OBSERVATION REPORT

Project: **Strata Plan LMS 280 - Chateau Comox**
1272 Comox Street
Vancouver, B.C.

File No: S18-558

ITEM: Building Envelope Field Review

Photos No. 11.1 and 11.2

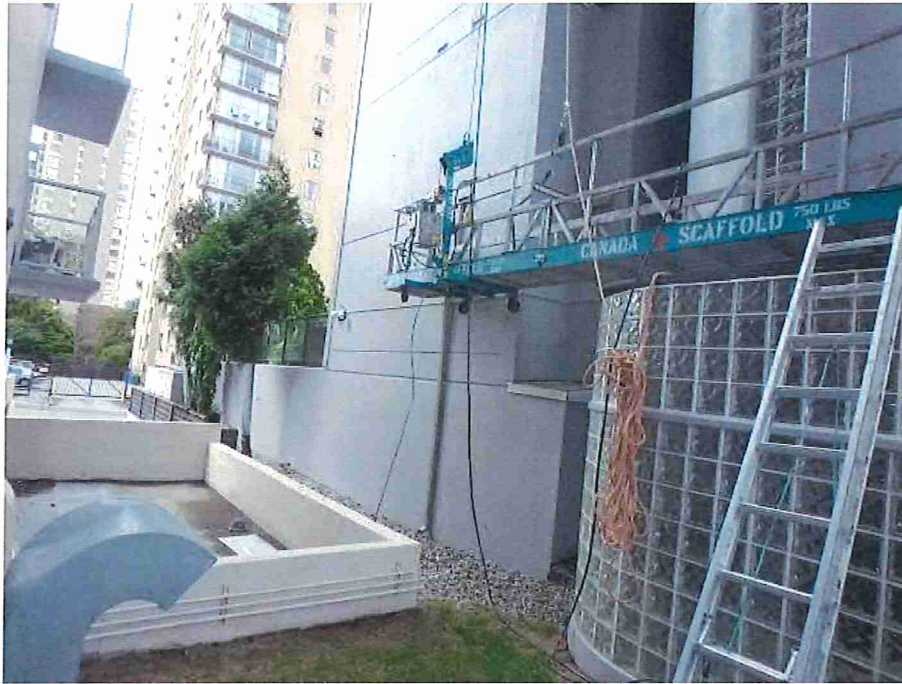
11.2	Work is now complete on the south half of the east elevation with good workmanship observed. New caulking has been applied and tooled to a smooth finish between the replacement stucco and existing exposed concrete (Photos No. 11.1 to 11.3).

Photos No. 11.3 and 11.4

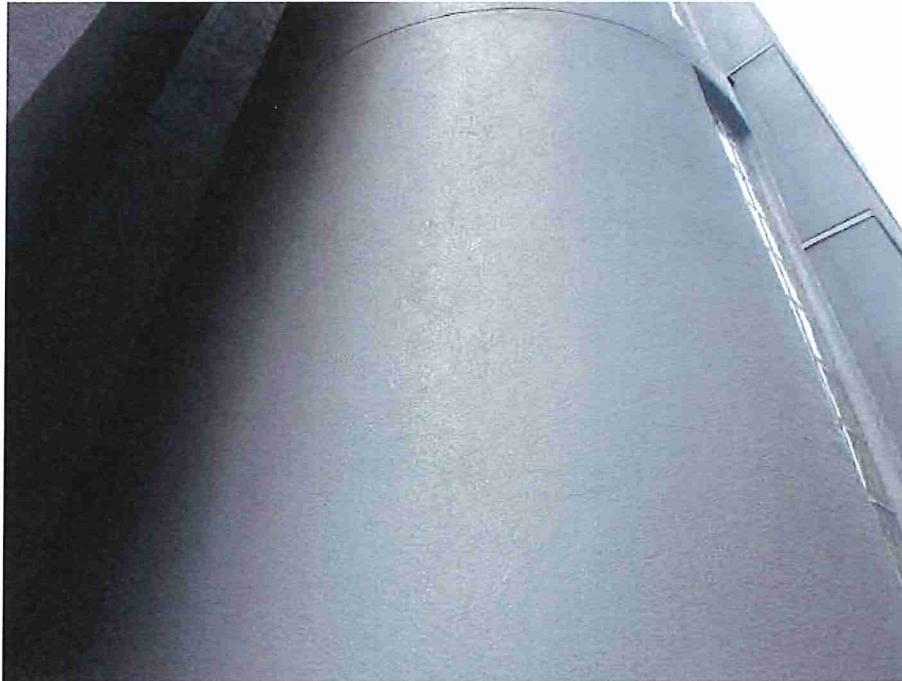
11.3	Floor line reveals, not previously caulked on the stairwell barrel wall, typically result in leaks to the interior. SEE instructed Spectrum Painting to apply new polyurethane caulking to each point. Where accessible from the swing stage, work will be done from the current drop. The returning portions of each joint will be accessed via Bosun's chair and work will be completed at hourly rates (Photos No. 11.4 and 11.5).

Photos No. 11.5 and 11.6

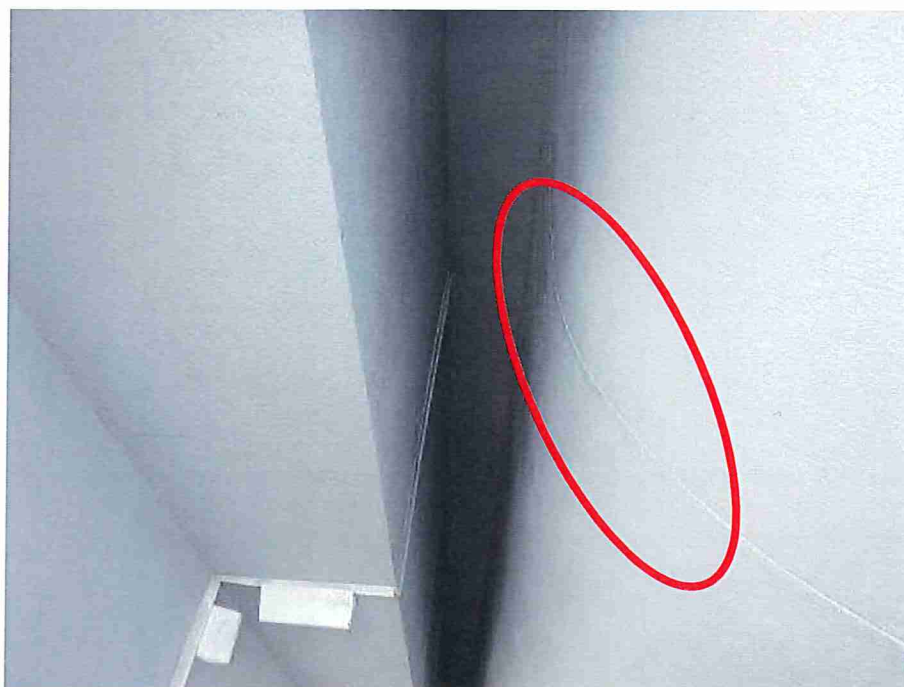
11.4 Stucco repairs continue to be done as loose areas are identified. At the base level of the east exit stairs there is failed acrylic stucco finish which has been scraped. It appears the stairs were faired with interior drywall compound which is relatively soft and susceptible to future water damage. Given the concealed location and limited visibility, SEE instructed Spectrum Painting to not reinstate new stucco finish but rather blend the edges of the removed areas and repaint over (Photos No. 11.6 to 11.8).
